**RE: 728-750 PRINCES HIGHWAY, TEMPE – PEER REVIEW ADDENDUM**

GTA Consultants (GTA) completed a peer review (reference N165200 dated 29/01/19) of the traffic impact assessment completed by Transport and Traffic Planning Associates (TTPA) dated October 2017 in support a Bunnings development at 728-750 Princes Highway, Tempe.

**Figure 1: Likely loss of Smith Street parking**

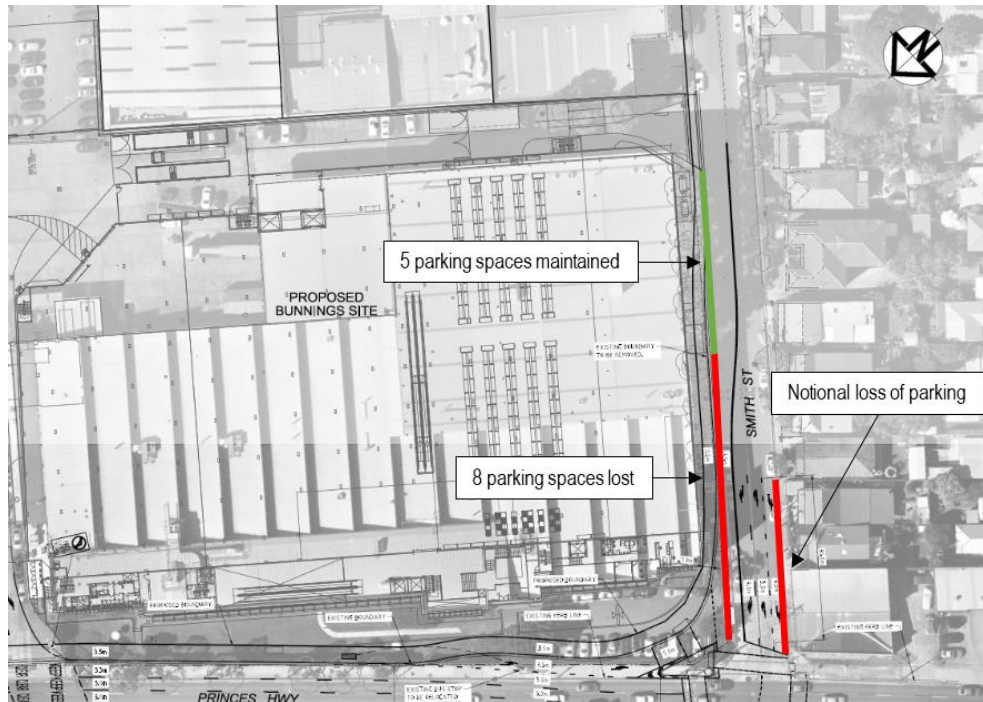
There is an existing capacity for approximately 13 vehicles to park on the northern side of Smith Street adjacent to the site. The proposed widening of Smith Street impacts these spaces, plus informal parking on the southern side, close to Princes Highway. A review of the civil plans for the proposed intersection layout and on-street parking along Smith Street indicates that approximately five spaces could potentially be maintained along the northern side of Smith Street (between Princes Highway and the Bunnings access), with the likely loss of eight spaces, as shown in Figure 1. The plans also include a 35-metre left turn lane on Smith Street on approach to Princes Highway. Based on existing kerbside parking restrictions, this would not technically result in a loss of on-street parking though observations confirm that vehicles have traditionally parked along this section and would hence result in further displacement.

While the formal loss of eight spaces is not excessive, observations confirm that parking on Smith Street is typically in relatively high demand. We note too that some of this demand would have historically catered for parking demand associated with the existing site, in addition to surrounding resident demand.

It is not clear if the impacts associated with this loss of parking has been considered as part of the development proposal or if alternative design solutions were considered through due project process. For example, parking demand surveys of Smith Street parking across a typical week would quantify demand and vacancy by area to better understand if the loss of parking as a result of the proposed development can be accommodated without triggering alternative measures.

While it is understood that the existing structure includes heritage items, there may be opportunity to investigate affecting part of the façade and southern structure to facilitate additional road widening in order to maintain parking on the northern side of Smith Street (and provide appropriate pedestrian amenity). It is also recommended that alternative intersection layouts be assessed in SIDRA (or information provided confirming this has been done) to ensure no further

intersection layout and operational efficiencies are possible. An obvious option is to assess two eastbound traffic lanes (rather than three) on Smith Street approach to Princes Highway.
